APPENDIX C.2

Geotechnical Inspection Report

RE: Submission of 2019 Geotechnical Inspection Report No. 1 (July 2019)

Annual Geotechnical Inspections – 2019 Report 1. Mary River Iron Mine Complex – Nunavut

Figure 27: MS-08 pond at the toe of the waste rock dump

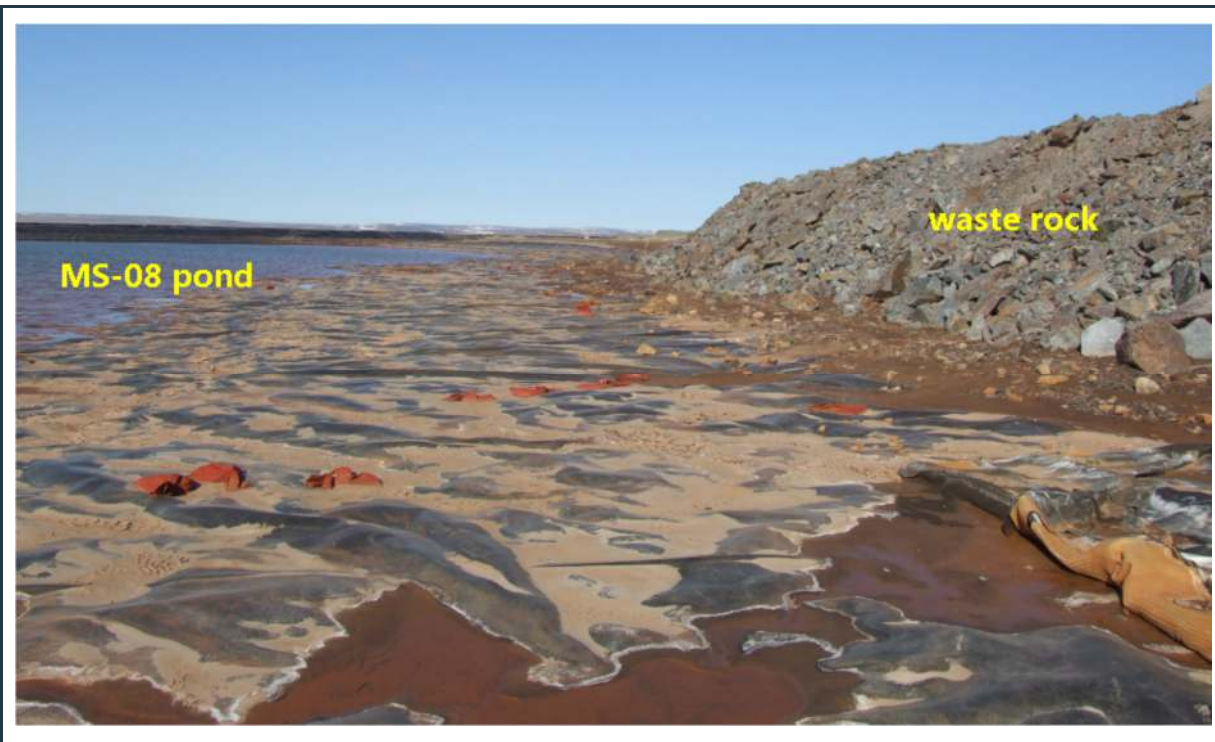
The MS-08 sedimentation pond is surrounded by a crescent shaped semicircular berm to the east, north and west and by the waste rock dump to the south, as shown in Figures 25 and 27 in Appendix A. Contact water from the waste dump area flows directly into the pond (see Figure 27) from the south, and conveyed to the pond via open ditches from the other sides of the dump. As shown in Figure 26, the construction of drainage ditches to allow for more flow capacity / minimize erosion is in progress.

Figure 49: Berm in excellent condition with stable slopes around the MP-01A pond

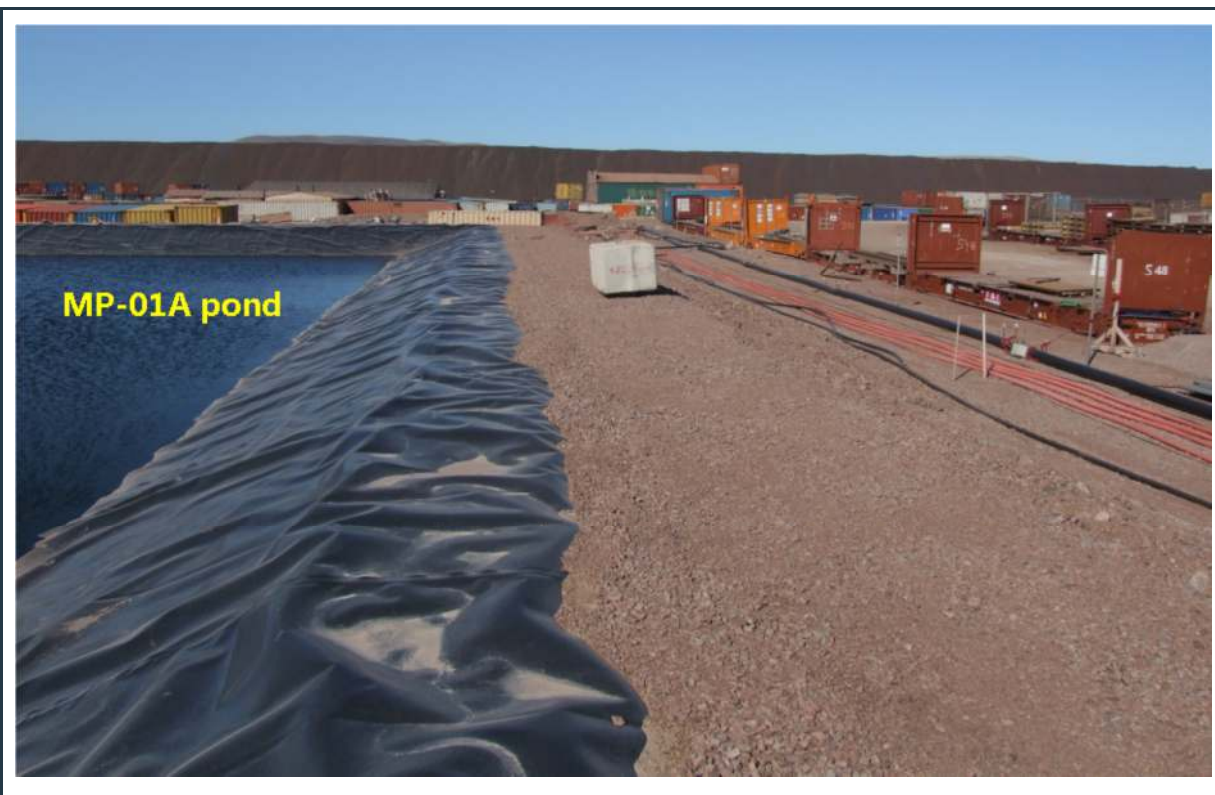
The new (2014) MP-01A polishing waste stabilization pond is located immediately south of the MP-03 fuel tank farm. As shown in Figure 49 the berm around the pond is in excellent condition and the liner appear to be intact. No sign of slope instability, settlement or seepage from the pond was noted during the field inspection.

Figure 77: View of the "old" abutments at bridge 63

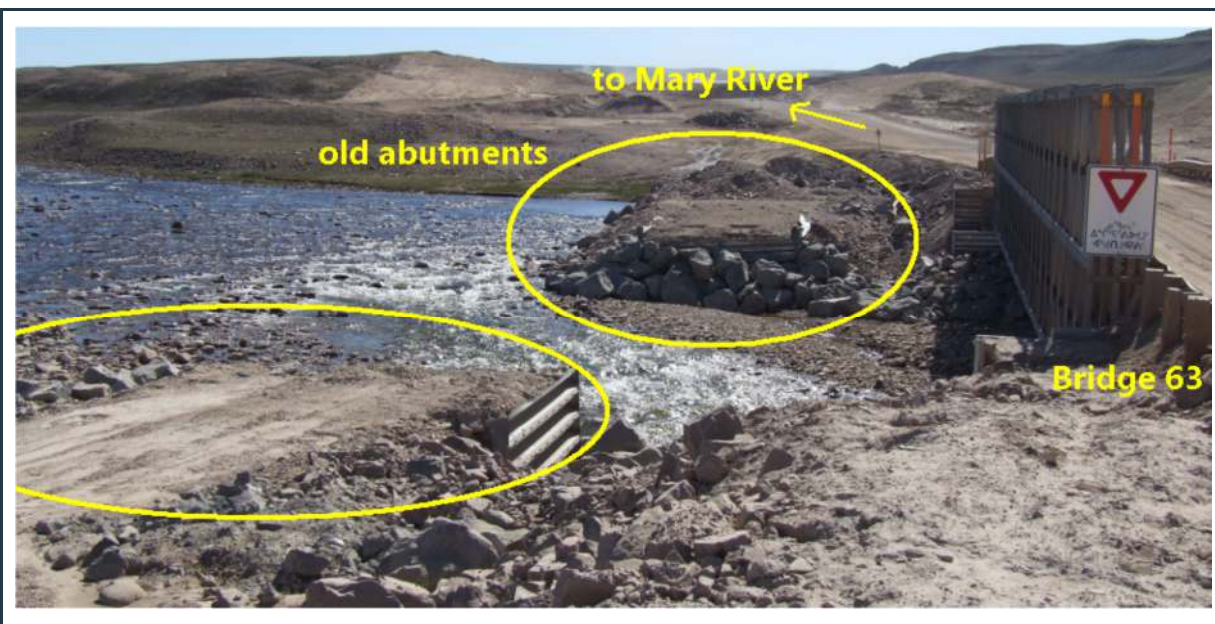
As shown in Figures 76 to 78, the abutments of this bridge are stable and no scour in the river-bed was noted during the site visit. The abutments show no differential settlement or any structural discrepancy like cracking on the foundation concrete. The wing-wall at the north-west abutment appears to be short and minor erosion of the road fill was noticed (Figure 78). At that location a metal section should be added to the wing-wall or alternatively some rock-fill be placed there to prevent soil erosion from the road into the river.

Figure 26: Water treatment pond adjacent to the waste rock dump and MS-08 (ice and snow covered).

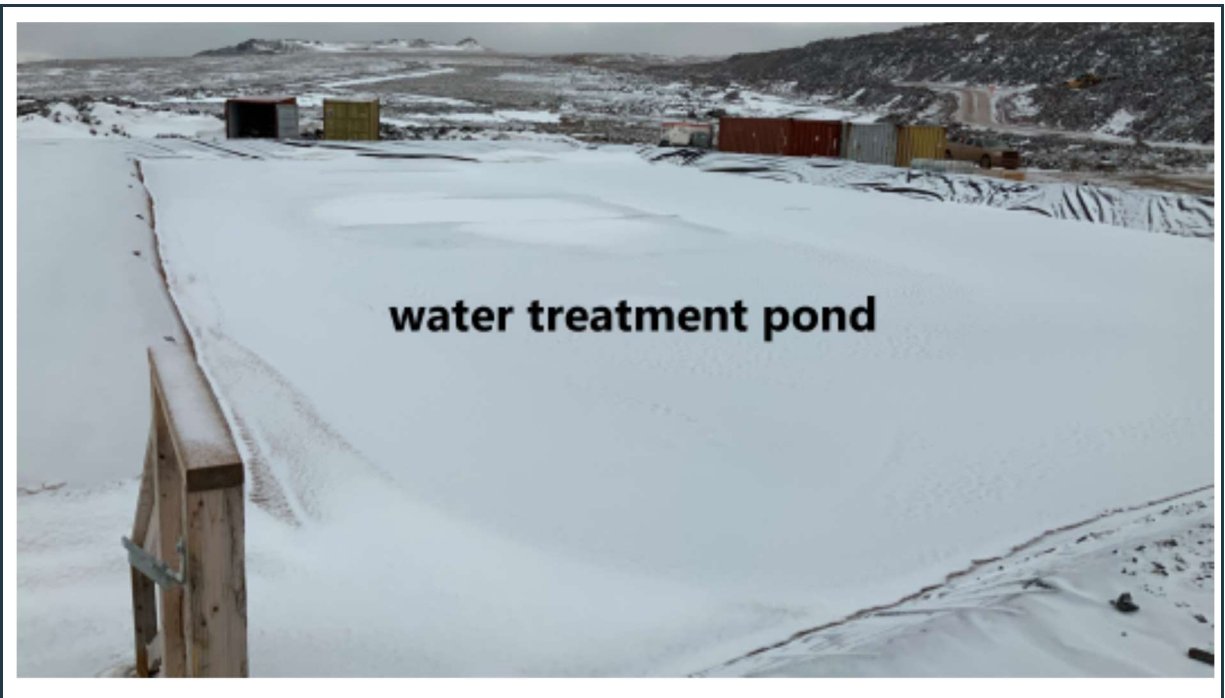
Water from the pond is pumped to the nearby designated facility for treatment. There is a lined treatment area located immediately next to the treatment plant with stable perimeter berms. Water treatment issues in relation to this area have not been reported and the entire facility appears to be fully functional. At the time of the inspection, the water in the pond was covered with ice and snow, as shown in Figure 26.

Figure 47: View of stable berms around the MP-04 landfarm.

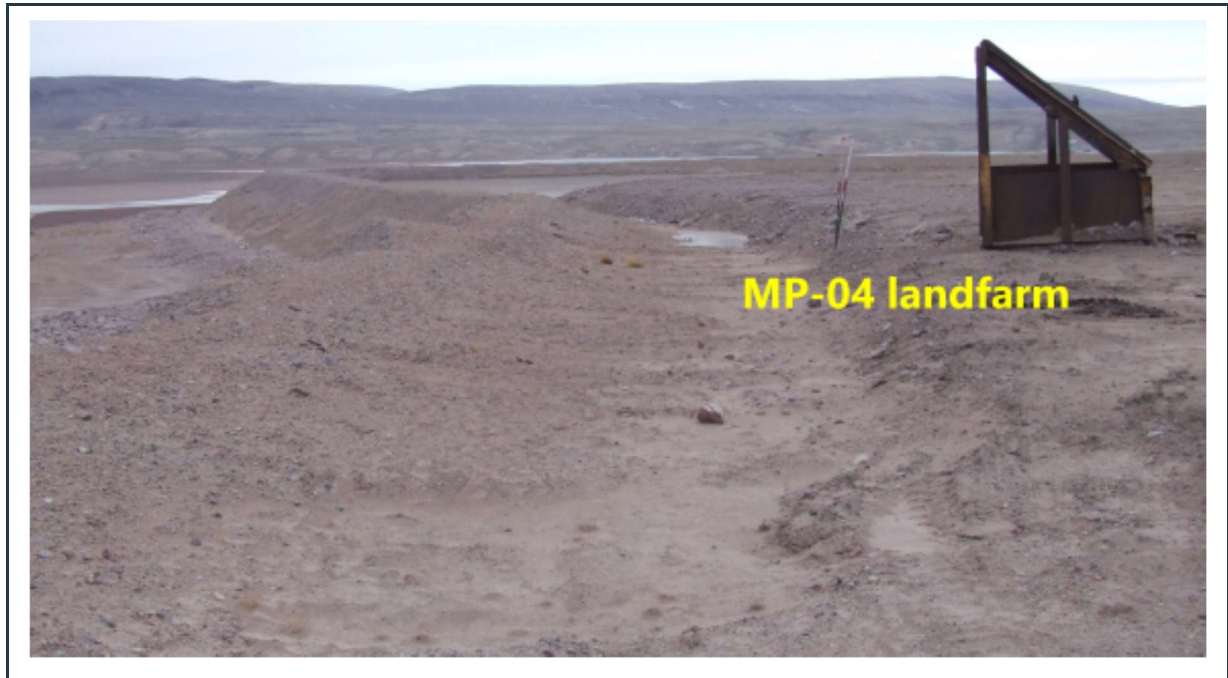
The MP-04 and MP-04A cells are located south of the port complex at higher elevation, adjacent to the rock quarry. MP-04 is a large landfarm cell that predominantly stores contaminated soils, as shown in Figure 47. The berm structure around the cell did not exhibit any signs of instability or evidence of seepage. However, the liner was found to be exposed (e.g. lacking protection of soil cover) on the downstream slope sections of the berm. This was particularly prominent along the north berm. It is recommended that the respective exposed liner areas (see Figure 48) be provided with protective gravel layer (e.g. wind uplift prevention).

Figure 50: View of the MP-05 pond, adjacent to the north-east corner of the ore stockpile.

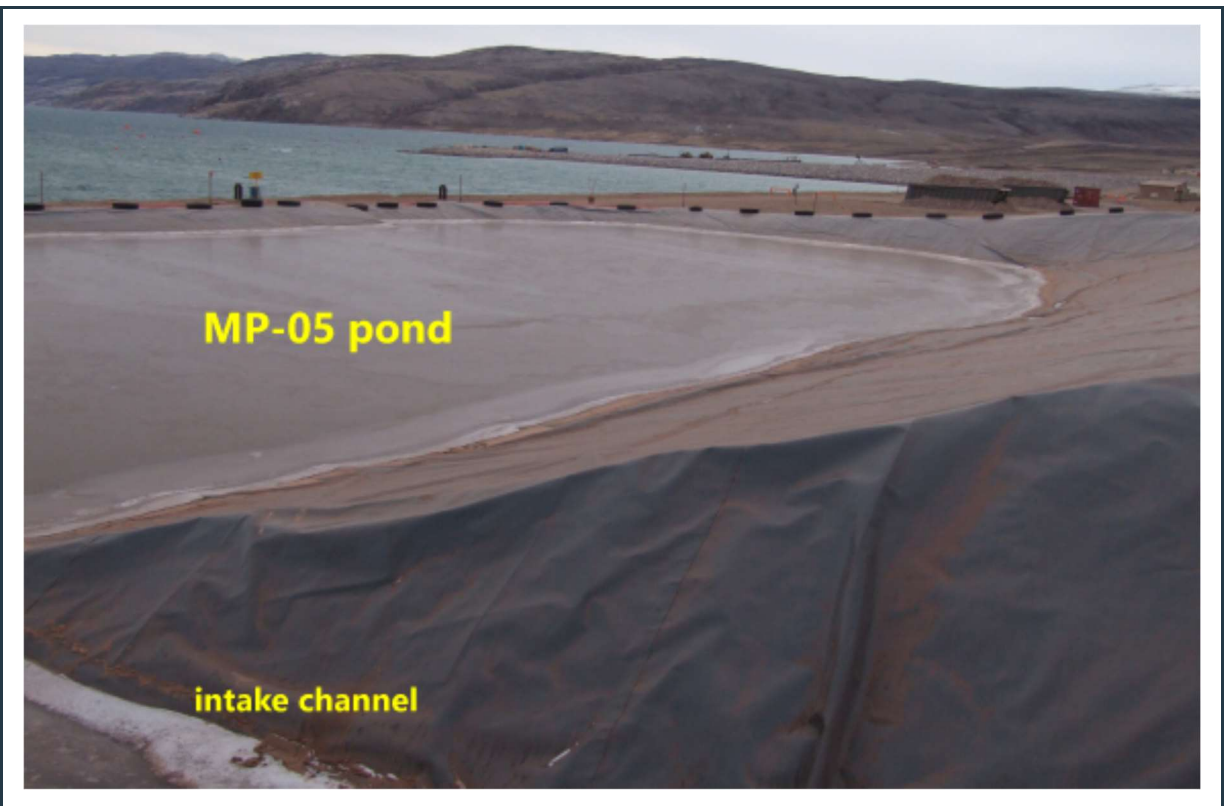
The high-grade iron ore that is mined, crushed, and screened at the Mary River site is transported to the Milne Inlet port, and stockpiled across a large flat area. Contact water in the area is collected along all sides of the ore stockpile in collection ditches and conveyed into two water collection ponds, MP-05 and 06 respectively (Figure 51).
